SUBJECT: Crystal River Unit 3
Docket No. 50-302
Operating License No. DPR-72

CRYSTAL RIVER UNIT NO. 3
 DESIGN INFORMATION AND TECHNICAL SPECIFICATIONS
 FOR REACTOR COOLANT PUMP POWER MONITORS

TECHNICAL SPECIFICATION CHANGE REQUEST NO. 27

Technical Specification Change Request No. 34 [Appendix A]

FIGURE 1

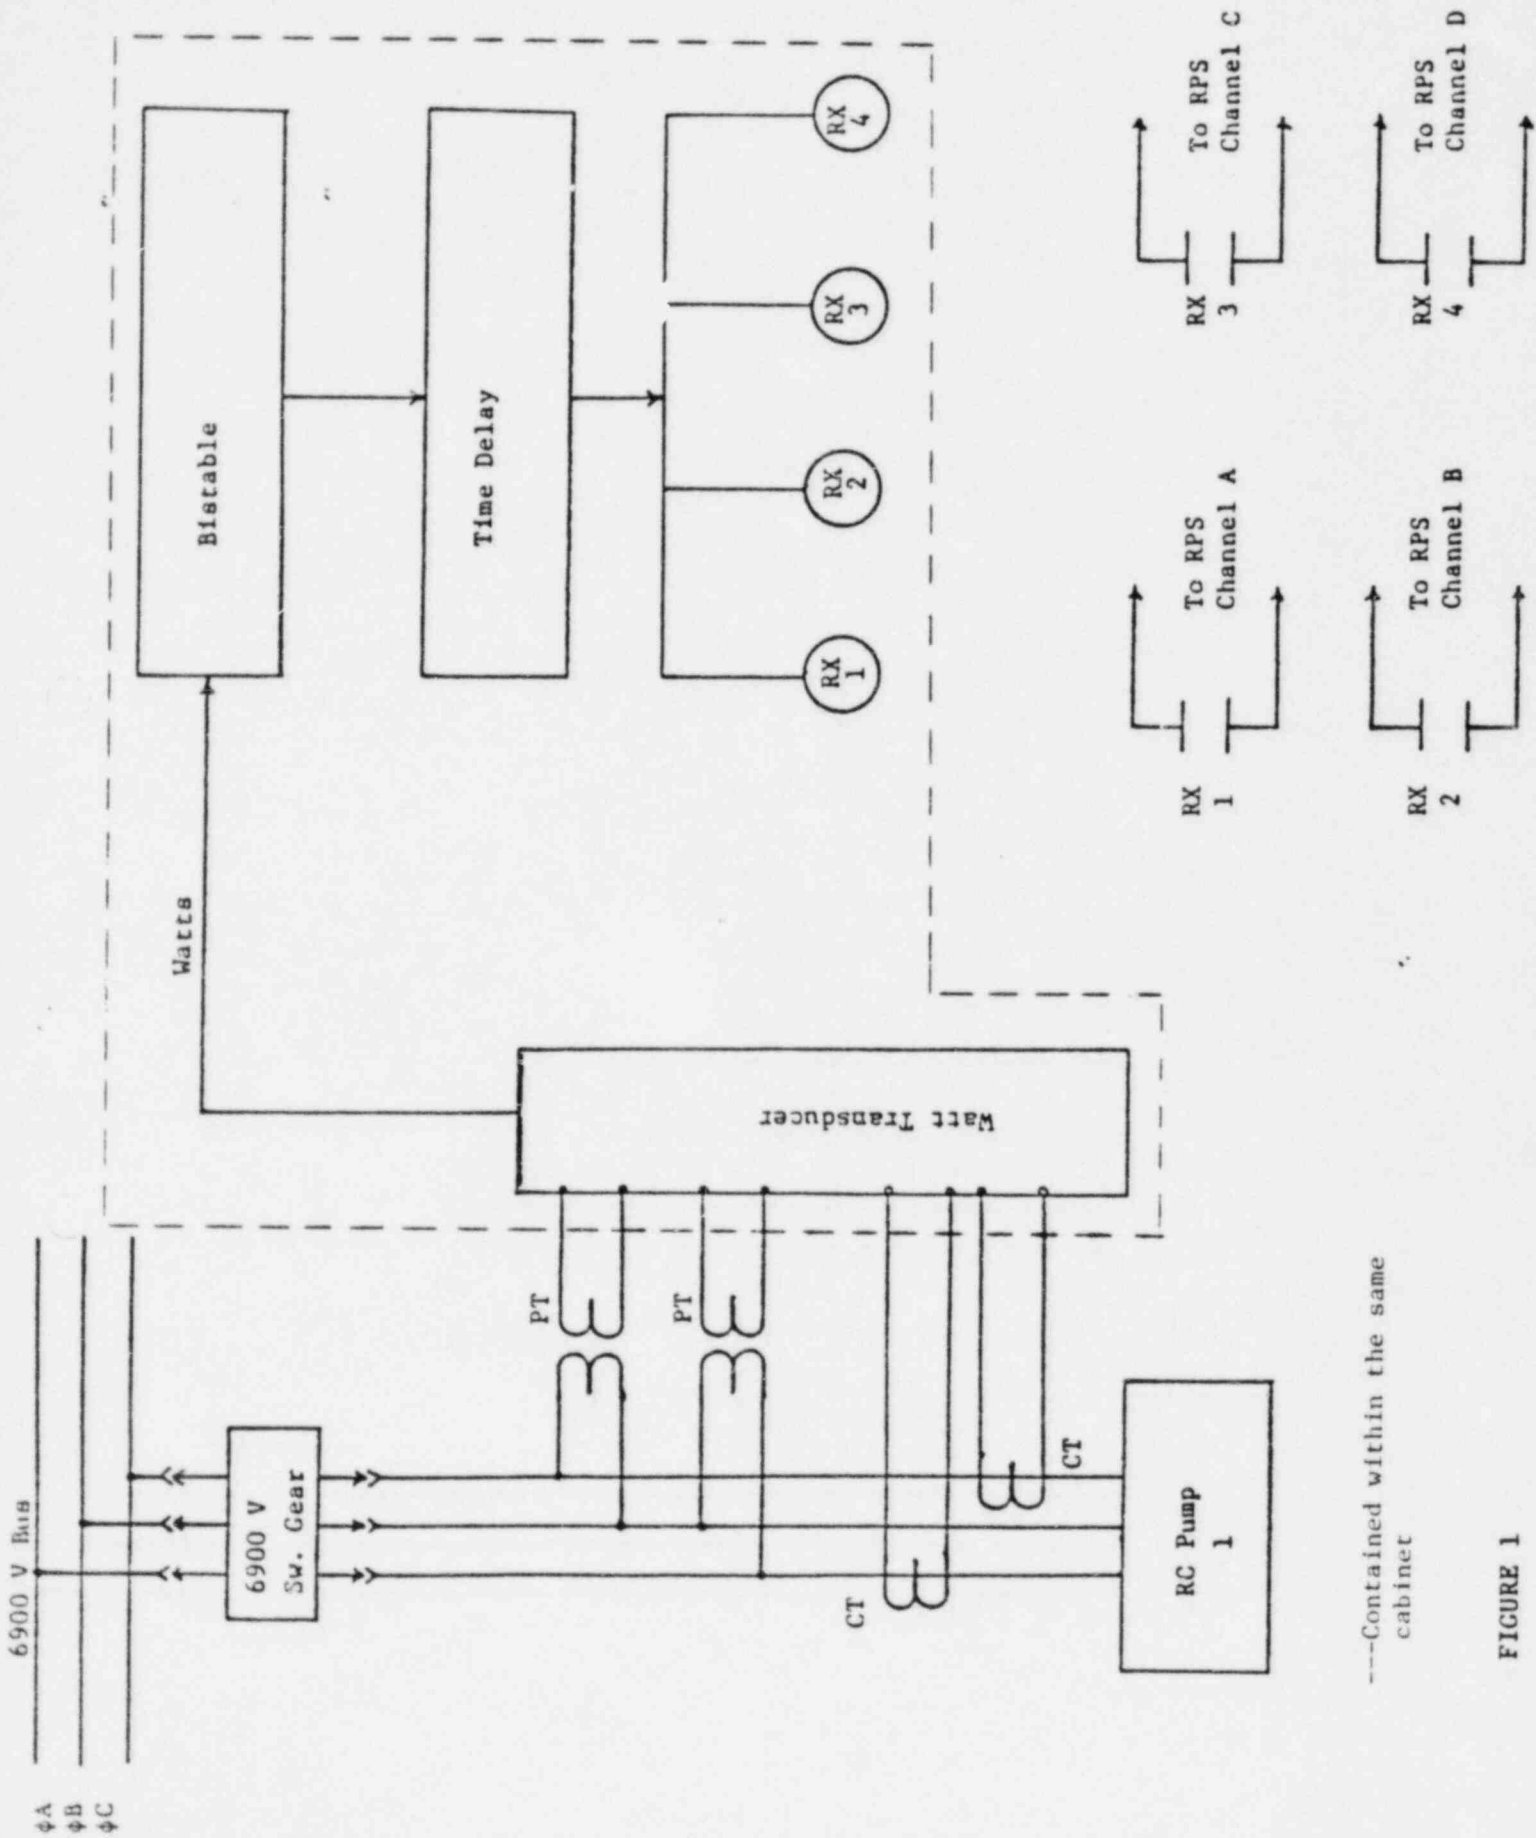
Figure 1 shows the proposed scheme for one RCPPM string. Two current transformers and a 3-phase potential transformer measure the current and voltage on the RCP pump power feed lines. The transformers input into a Hall effect watt transducer which produces an output signal proportional to real power. This power signal is fed into a bistable which provides a contact output for selected overpower and underpower setpoints. The bistable output contact is wired to a time delay relay to provide a time delay function sufficient to permit normal pump bus transfer without reporting a "pump inoperable" status to the RPS. The output of the timer actuates four separate relays. A contact from each relay is wired to its

respective RPS channel. Thus, one pump monitor string provides status information for one pump to each of four RPS channels. An identical, redundant string (not shown in Figure 1) using separate transformers and monitoring equipment again provides status information for the same pump to the four RPS channels. In the event of a failure of one string, all four RPS channels would still have the necessary pump status information via the redundant string.

FIGURE 2

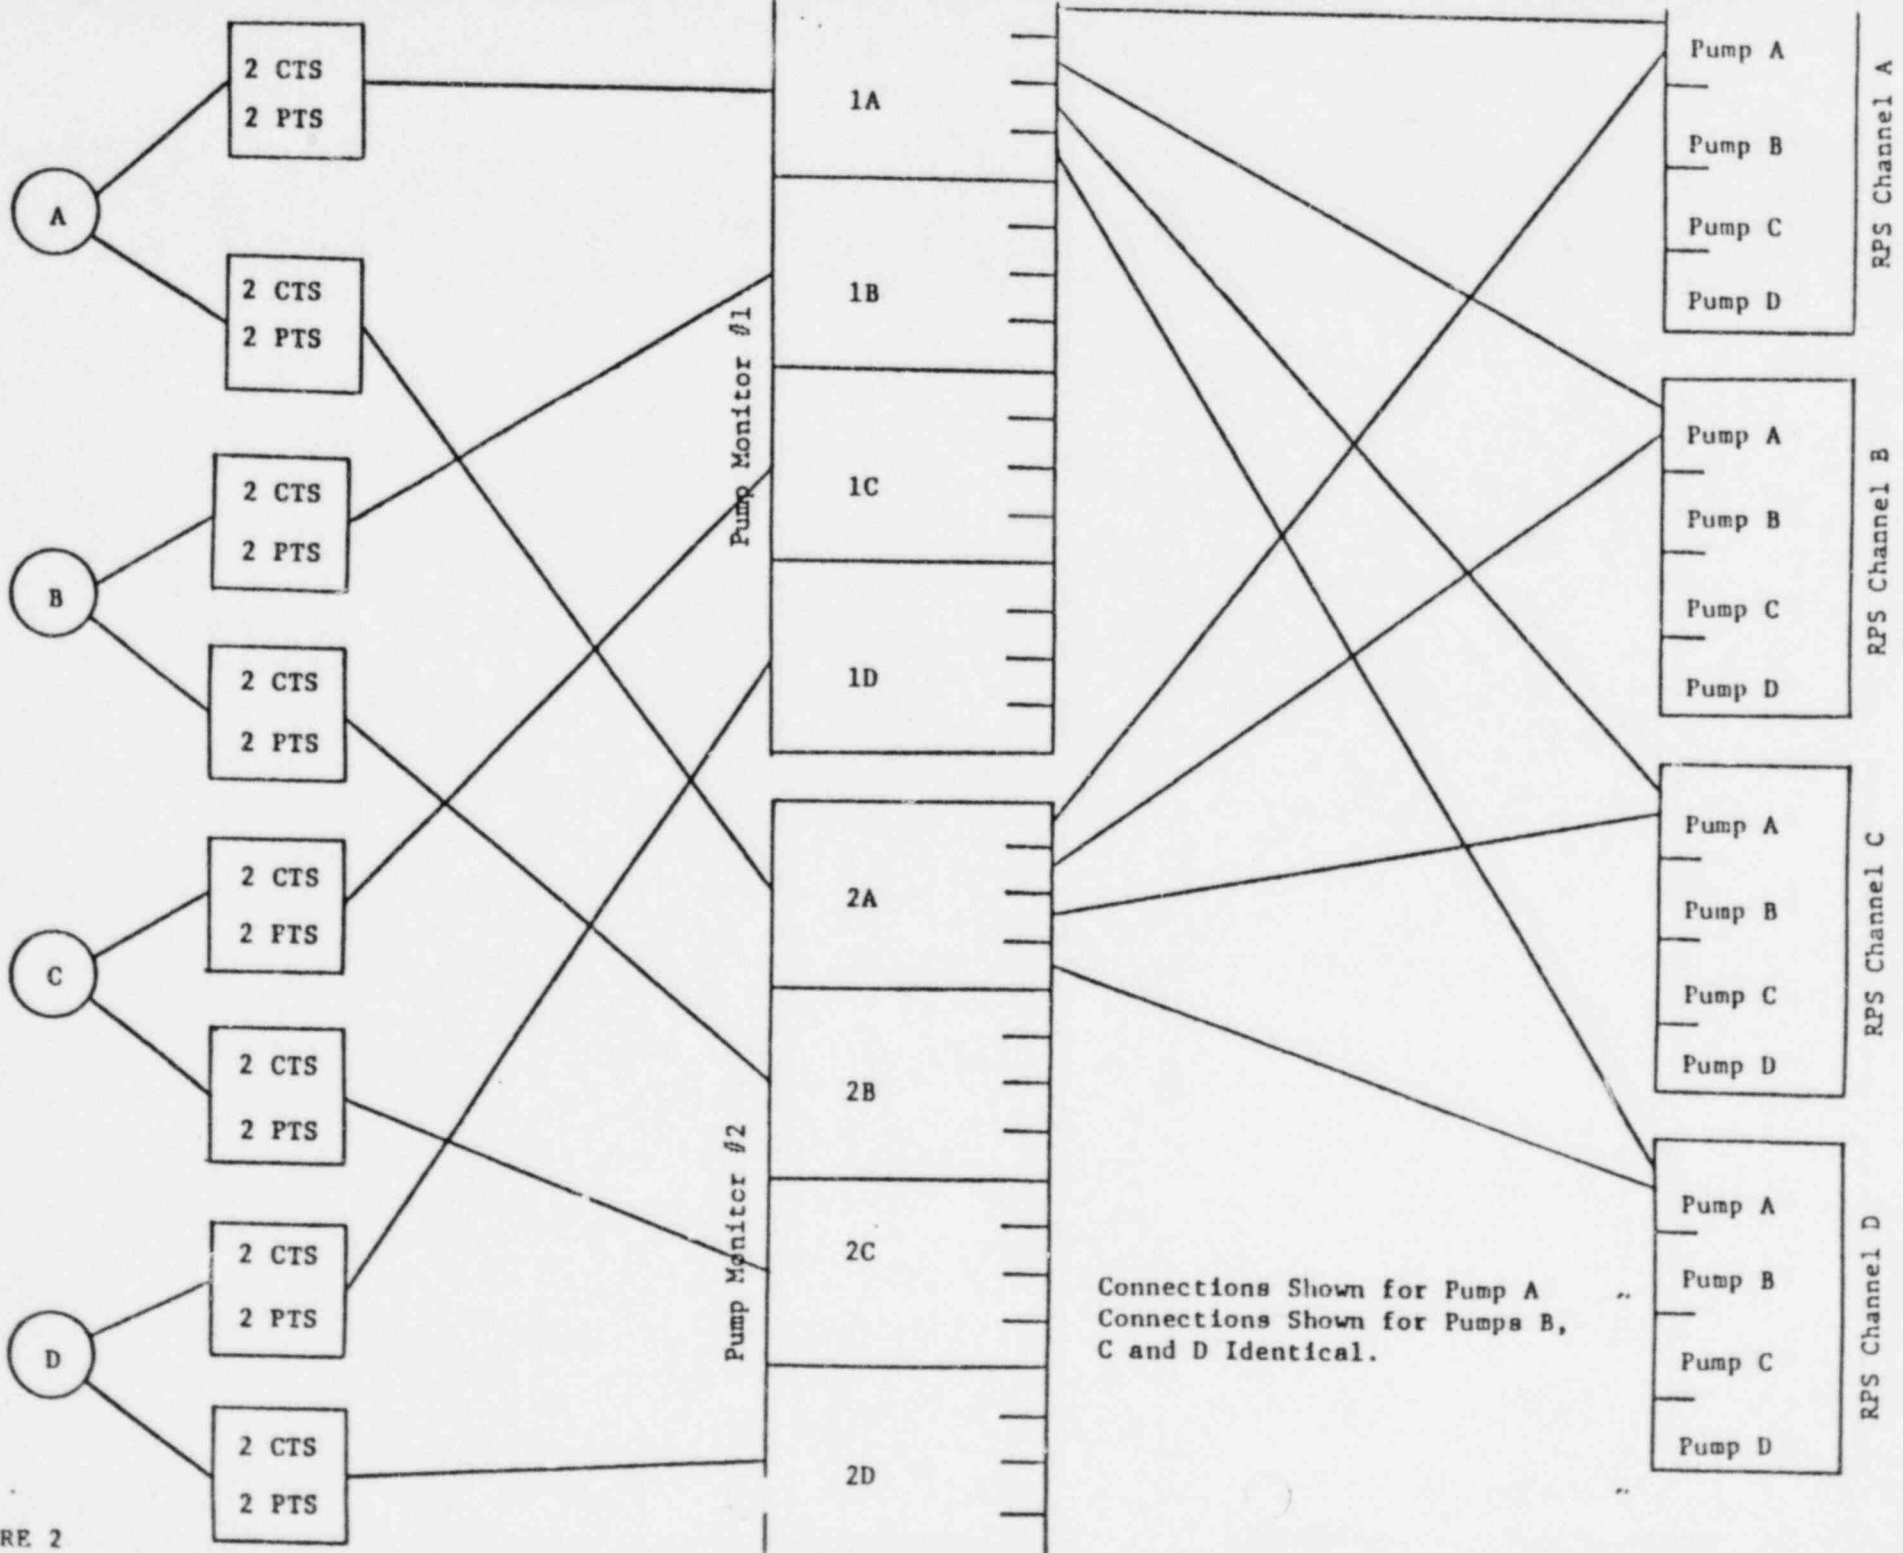
Figure 2 shows a block diagram of the complete RCPPM system. The system will be packed such that equipment belonging to redundant strings will be in enclosures separated by barriers. Contact outputs from the RCPPM cabinets to the four RPS channels will be arranged to provide adequate physical separation and electrical isolation between each channel. Cable and equipment separation for this installation will be in accordance with IEEE 384-1977 and Regulatory Guide 1.75. Where separation cannot be maintained, physical barriers will be included.

Figure 3.4-2

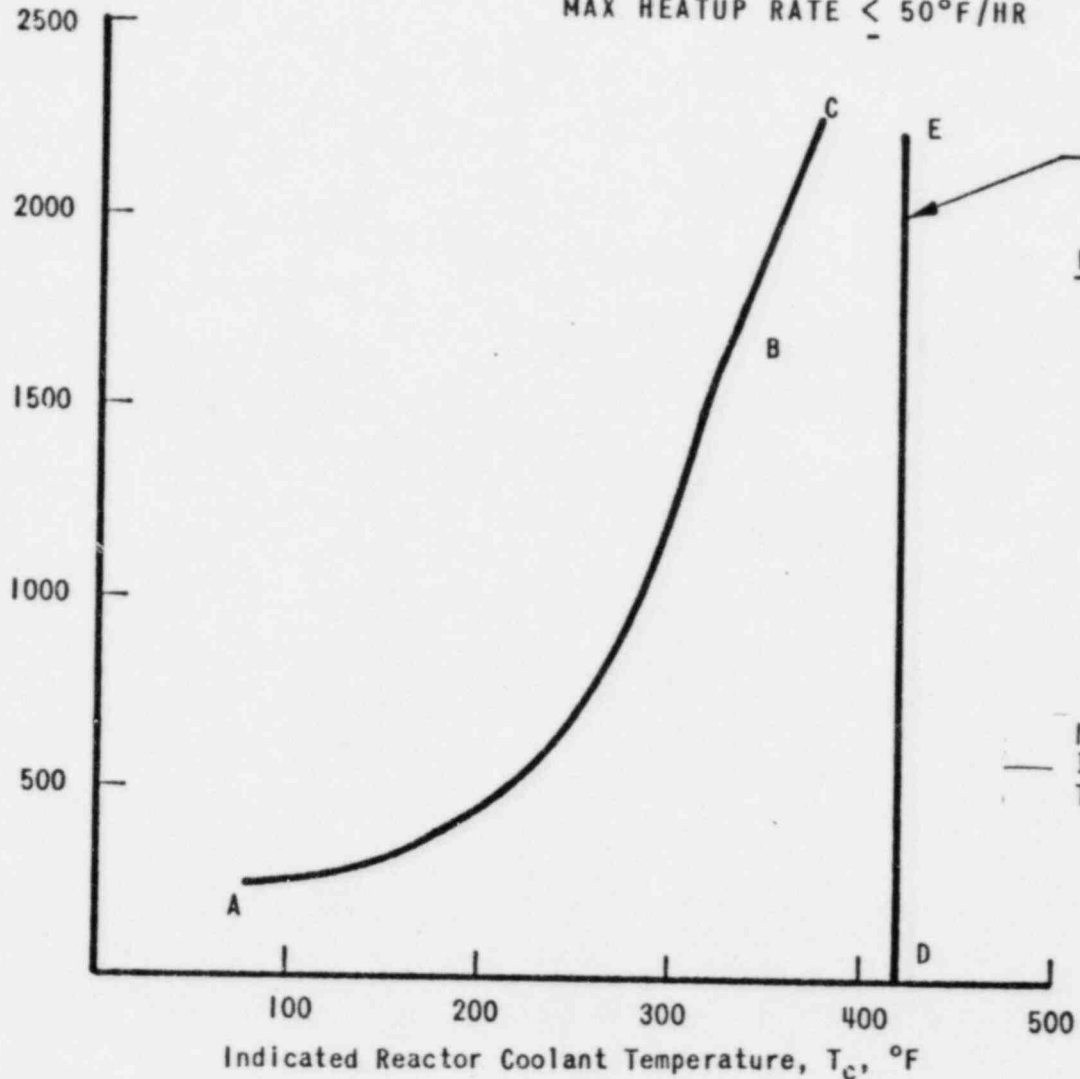
Revisions to the heatup, cooldown, and inservice leak and hydrostatic test pressure-temperature curves are proposed as well as the supporting bases.

B&W has advised that as a result of chemical analysis performed on archive weldments in conjunction with the B&W owner's group program for evaluation of reactor vessel material properties, it was discovered that weld filler wire atypical of the submerged arc weld filler wires used by B&W in the construction of nuclear pressure vessels was unknowingly mixed by the supplier with a shipment of Mn-Mo-Ni filler wire. The atypical weld wire has high Silicon and low Nickel contents which are outside of the typical range for the Mn-Mo-Ni filler wires specified by B&W; specifically, the Ni content was 0.1% (typically 0.6%) and the Si content was 1.0% (typically 0.5%). There are no directly applicable irradiation data for the atypical weldment although other applicable data exists, and furthermore, welds of this wire possess a higher than normal unirradiated reference temperature, RT_NDT. Weldments prepared from the atypical weld wire exhibit a very adequate Charpy Upper Shelf Energy.

The heatup limit curve, Figure 3.4-2 is a composite curve which was prepared by determining the most conservative case, with either the 1/4T or 3/4T wall location controlling, for any heatup rate up to the indicated maxima per hour. The cooldown limit curve, Figure 3.4-3, is a composite curve which was prepared based upon the same type analysis.

3.4.9.1 The Reactor Coolant System (except the pressurizer) temperature and pressure shall be limited in accordance with the limit lines shown on Figures 3.4-2, 3.4-3, and 3.4-4 during heatup, cooldown, criticality, and inservice leak and hydrostatic testing with maximum heatup and cooldown rates as indicated on the applicable figure.

Figure 3.4-4

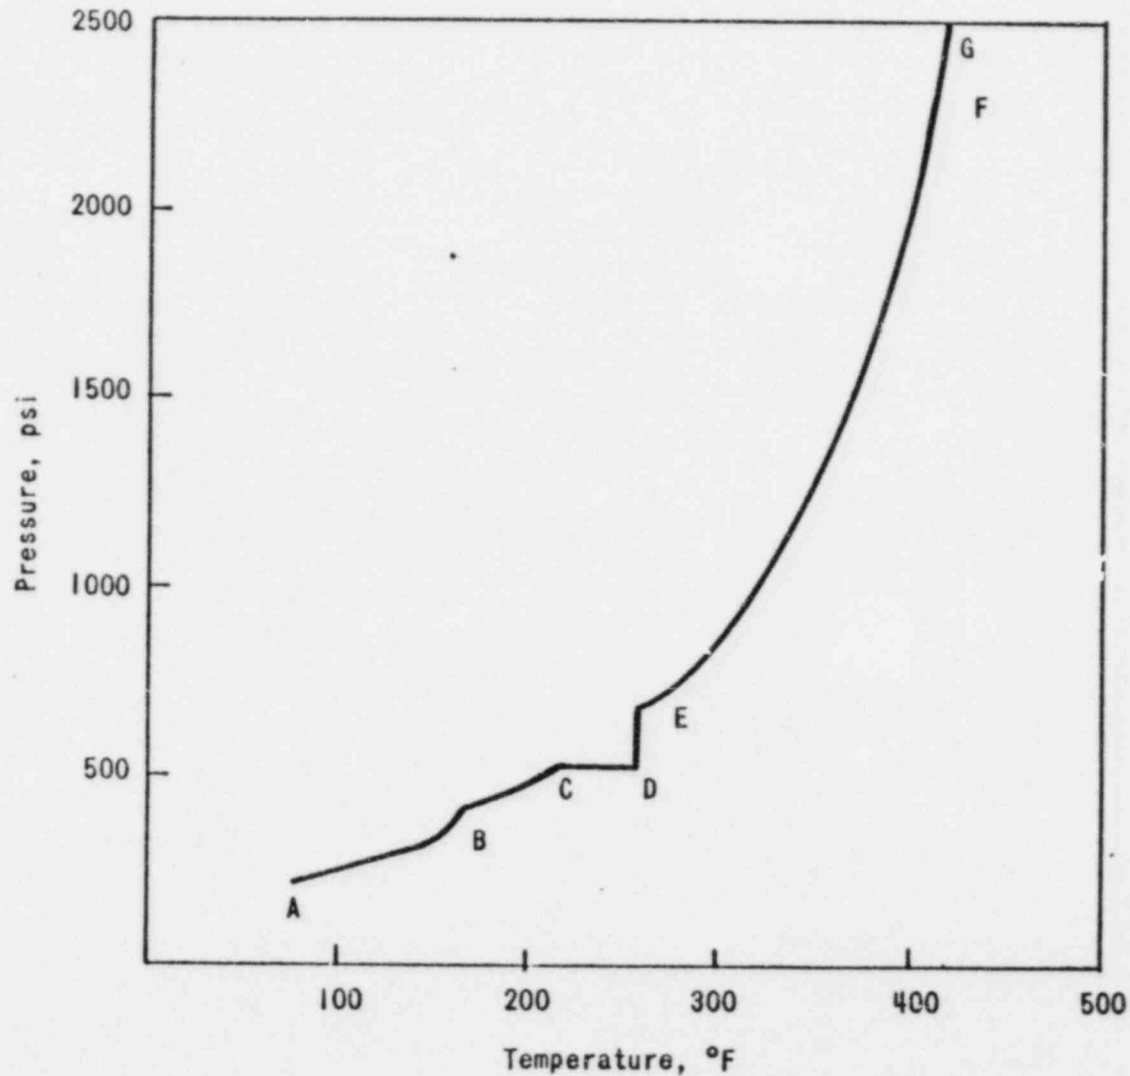
Figure 3.4-2 presents the pressure-temperature limit curve for normal heatup. This figure also presents the core criticality limits as required by Appendix G to 10 CFR 50. Figure 3.4-3 presents the pressure temperature limit curve for normal cooldown. Figure 3.4-4 presents the pressure-tempera-
